AFMSS
U.S. Department of the Interior
BUREAU OF LAND MANAGEMENT

Well Name: AMAX 24 FEDERAL
Well Location: T23S / R31E / SEC 24 / SWSW / 32.2840151 / -103.7389486
County or Parish/State: EDDY / NM

Notice of Intent

NOI TO PERMANENTLY ABANDON THIS WELL VIA CEMENT PLUGGING.

PROPOSED WELLBORE

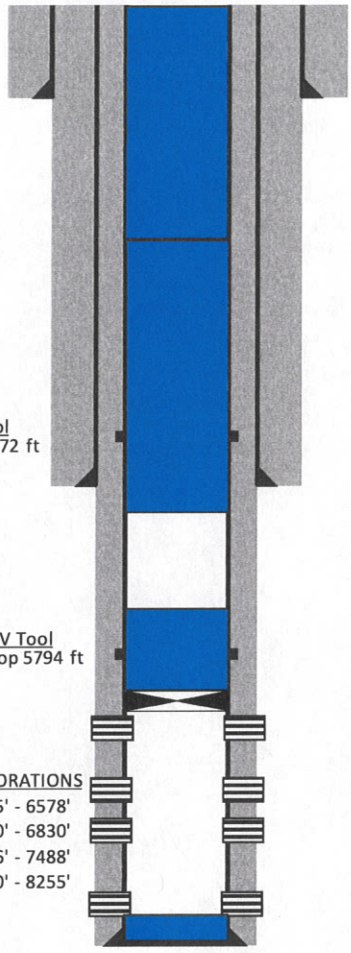
Sundry ID	2907805						
Plug Type	Top	Bottom	Length	Tag	Sacks	Cement Class	Notes
Surface Plug	0.00	100.00	100.00	Tag/Verify			
13.375 inch- Shoe Plug	773.68	882.00	108.32	Tag/Verify			
Fresh Water @ 1030	969.70	1080.00	110.30	If solid			
Top of Salt @ 1245	1182.55	1295.00	112.45	Tag/Verify			
DV tool plug	3981.28	4122.00	140.72	Tag/Verify			
Base of Salt @ 4222	4129.78	4272.00	142.22	Tag/Verify

8.625 inch- Shoe Plug	4226.80	4370.00	143.20	Tag/Verify	256.00	C	Spot cement from 2263' to surface. Verify at surface.
Delaware @ 4458	4363.42	4508.00	144.58	If solid base no need to Tag (CIBP present and/or Mechanical Integrity Test), If Perf & Sqz then Tag, Leak Test all CIBP if no Open Perforations	256.00	C	Spot cement from 4526' to 2263'. WOC and Tag.
DV tool plug	5686.06	5844.00	157.94	Tag/Verify			
CIBP Plug	6020.00	6055.00	35.00	If solid base no need to Tag (CIBP present and/or Mechanical Integrity Test), If Perf & Sqz then Tag, Leak Test all CIBP if no Open Perforations	84.00	C	Set CIBP at 6055'. Leak test CIBP. Spot cement from 6055' to 5686'. WOC and Tag.
Perforations Plug (If No CIBP)	6055.00	8305.00	2250.00	Tag/Verify

Bonesprings @ 8302	8168.98	8352.00	183.02	If solid base no need to Tag (CIBP present and/or Mechanical Integrity Test), If Perf & Sqz then Tag, Leak Test all CIBP if no Open Perforations	31.00	H	Tad PBTD and spot cement from PBTD to 8168'. WOC and Tag.
5.5 inch- Shoe Plug	8325.40	8510.00	184.60	Tag/Verify

Created By	Condition	Condition Date
gcordero	Run RCBL with zero psi, keep hole loaded, log 6055' to Surface.	8/27/2026
gcordero	A Cement Bond Log (CBL) is required to be submitted to electronic permitting.	8/27/2026
gcordero	Submit Cement Bond Logs (CBL) prior to submittal of C-103P.	8/27/2026
